ANN ARBOR HISTORIC DISTRICT COMMISSION**Staff Report****ADDRESS:** 613-619 E William Street and 342 S State, Application Number HDC19-168**DISTRICT:** State Street Historic District**REPORT DATE:** September 12, 2019**REPORT PREPARED BY:** Jill Thacher, Historic Preservation Coordinator**REVIEW COMMITTEE DATE:** Monday, September 9, 2019

APPLICATION: The applicant seeks HDC approval to install new storefronts along the extent of the two-story building and replace a side door facing E William on 342 S State, in the existing opening.

RE: State & William Historic Façade Improvements, O|X Project SWF19
Historic District Commission Review

2 South Elevation - Proposed Storefront Design
 A-100
 2'-8" 5'-4" 10'-8" 3/16" = 1'-0"

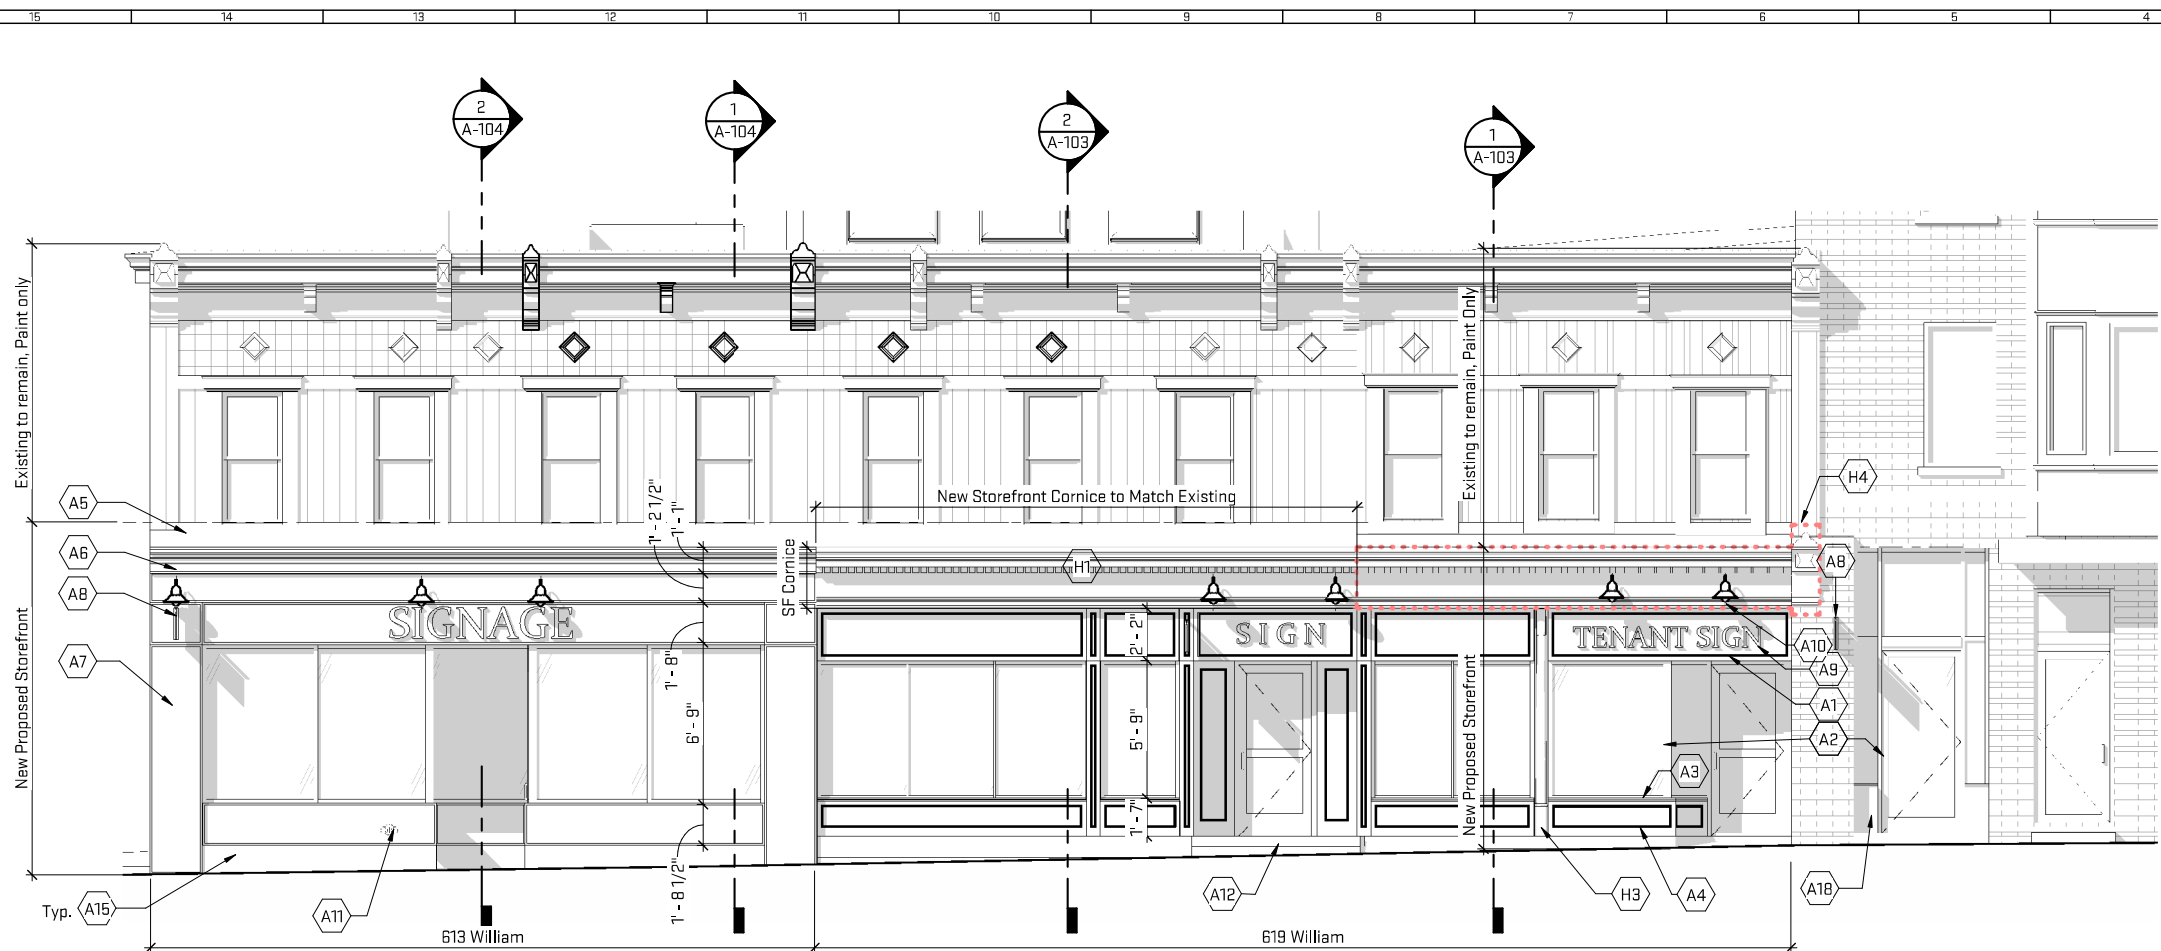
1. The storefront in 619 was approved by the HDC in 2001. The original design, with a recessed double entry in the center of 617 and 619, is not reproduceable because of interior changes to the original layout. The proposed storefronts carry the first floor cornice trim from 619 through 617, and retain the basic proportions and large pieces of glass seen in photographs from the 1940s. The cornice on 613 is simplified, since historic documentation of what it originally looked like does not exist. The element most obviously missing is the transom window originally found on 617-619.

2. A sign band is being shown where the transoms would historically go above the new storefronts. Signage is shown on the plans and staff asks that the applicant submit dimensions of those sign areas (three wall signs and three pedestrian scaled bracket signs). If approved by the HDC, this will allow staff to approve future signage that does not exceed those dimensions, in the same locations. Any other signage must be approved by the HDC instead of staff.

2 South Elevation - Proposed Storefront Design
 A-101 1/4" = 1'-0"

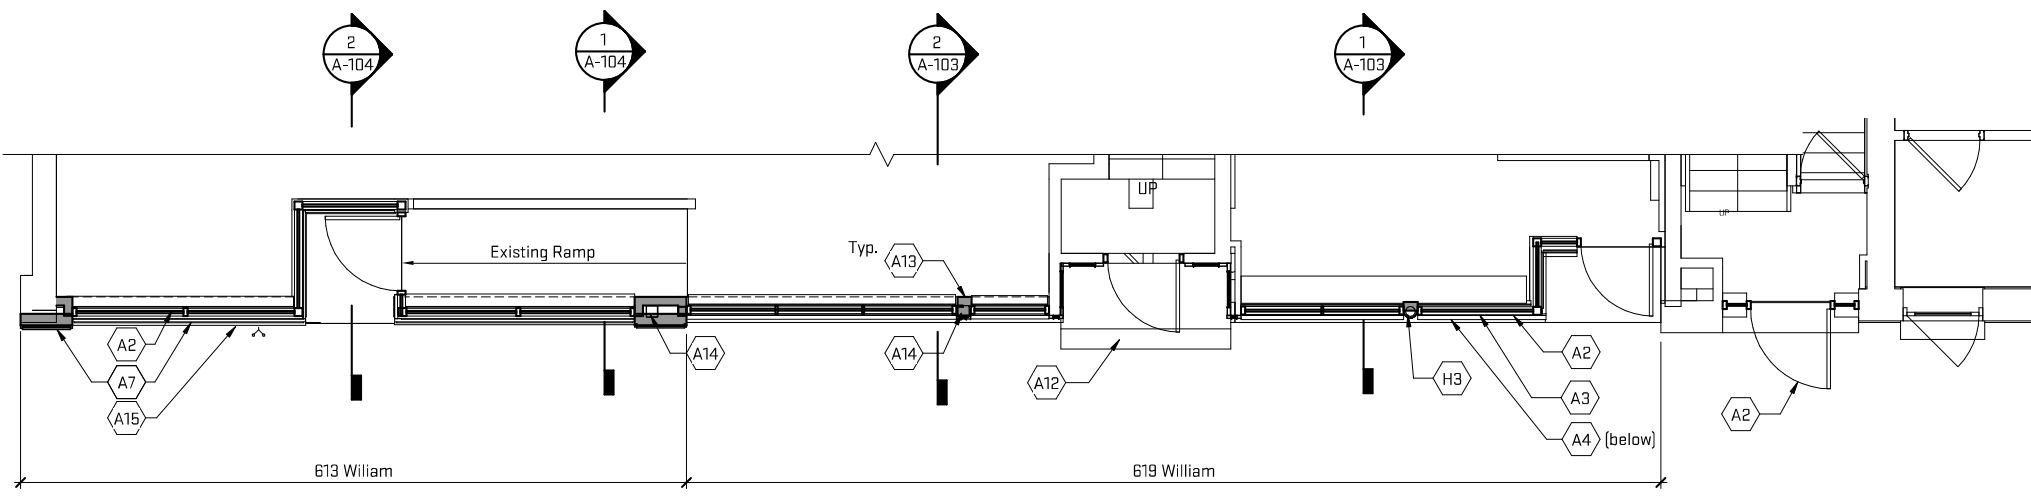
3. The signs show gooseneck lighting with a 12 5/8" diameter shade. The HDC's policy has been to not allow new gooseneck lights, and staff can only recall one in recent history (an exception was made for Salads Up). The fixtures proposed here are more modern than a traditional barn light, but staff's opinion is that they are still goosenecks. Elevation drawings A101-102 show two goosenecks per each of the three signs, plus one on the westernmost pedestrian scale sign. The color images are inconsistent in the number and placement of lights, but staff defaults to what is shown on the elevations. Since there are streetlights in front of 619 and 611 E William (across the alley to the west), staff has concerns that the lights will be overkill. If the HDC believes the fixtures are appropriate, the suggested motion is conditioned on limiting the lighting to two fixtures on the signs at 613 and 619, one on 617, and none on the two bracket signs.
